# UNITED STATES PATENT AND TRADEMARK OFFICE

APPLICATION NO.	FILING DATE	FIRST NAMED INVENTOR	ATTORNEY DOCKET NO.	CONFIRMATION NO.
10/557,820	11/23/2005	Kwan Young Han	074998-0012	2544
20277 7590 09/14/2007 MCDERMOTT WILL & EMERY LLP 600 13TH STREET, N.W. WASHINGTON, DC 20005-3096			EXAMINER TRAN, TONY	
			ART UNIT 2818	PAPER NUMBER
			MAIL DATE 09/14/2007	DELIVERY MODE PAPER

<b>Office Action Summary</b>	Application No. 10/557,820	Applicant(s) HAN ET AL.	
	Examiner Tony Tran	Art Unit 2818

## DETAILED ACTION

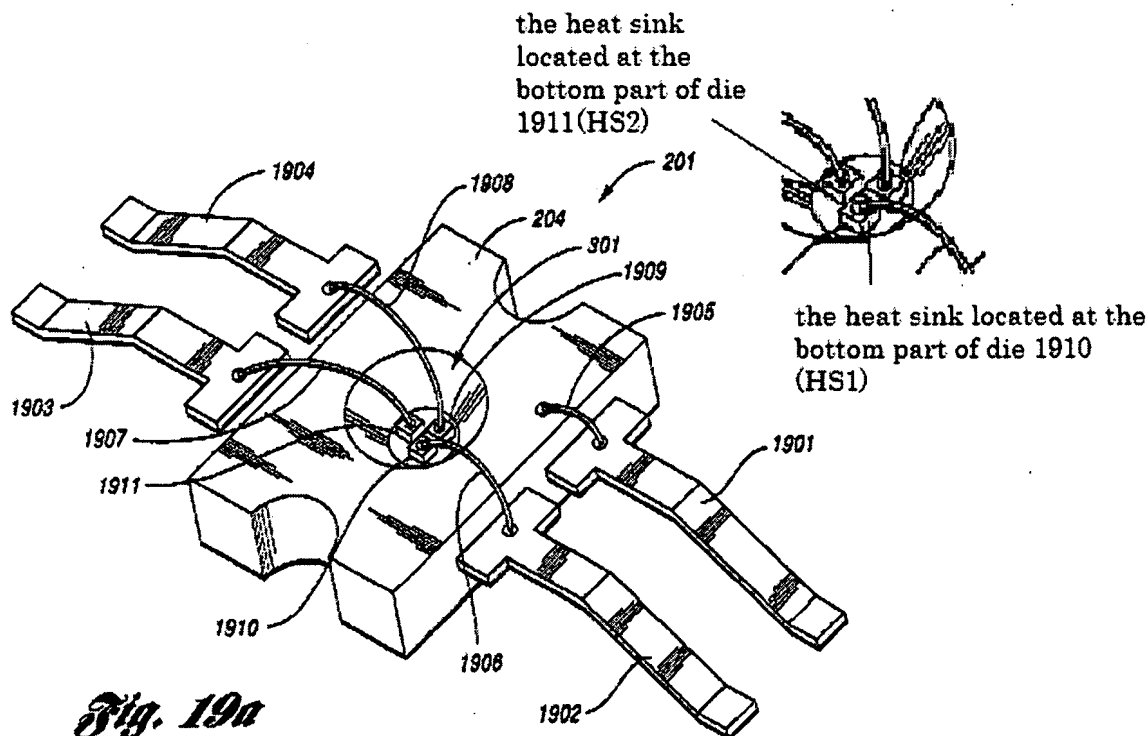
Regarding Claim 1, Roberts, one embodiment, FIGS. 19A-19B teaches a high power light emitting diode package comprising:

a main body (204, col. 29, lines 61-65);

at least two lead terminals (1902 & 1903, col. 30, lines 5-10) fixed to the main body (204); and

at least two heat sinks (HS1 & HS2, FIG. 19a as shown above, note that HS1 and HS2 are sitting on top of heat extraction 204 which are conducting heat to 204 they are considering as the heat sinks) of electrically and thermally conductive materials, the heat sinks being separated from each other and fixed to the main body (204).

Regarding Claims 2-3, Roberts, one embodiment, FIGS. 19A-19B further teaches the package of claim 1, wherein each of the at least two heat sinks (HS1 & HS2) has a reflective surface (301, col. 30, lines 9-11 & col. 12, lines 10-15) extended from an upper surface thereof (claim 2).

wherein the at least two heat sinks are a pair (HS1 & HS2, FIG. 19a as shown above) (claim 3).

Regarding Claim 4, Roberts, one embodiment, FIGS. 19A-19B further teaches the package of claim 3, further comprising: at least one light emitting diode die (top part of die 1910 or 1911) mounted on upper surfaces of the at least two heat sinks (HS1 & HS2), the die (1910 & 1911) being directly and electrically connected to the heat sinks (HS1 & HS2) through a surface of the die (top surface of 1910 & 1911).

Regarding Claim 5, Roberts, one embodiment, FIGS. 19A-19B further teaches the package of claim 4, further comprising: bonding wires (1906 & 1907) electrically connecting the at least two lead terminals (1902 & 1903), the at least two heat sinks (HS1 & HS2) and the at least one light emitting diode die (1910 & 1911).

Regarding Claim 6, Roberts, one embodiment, FIGS. 19A-19B further teaches package of claim 4, further comprising: a lens (401, col. 30, lines 9-10) attached to the main body (204), the lens (401) enclosing the at least one light emitting diode die (1910 & 1911).
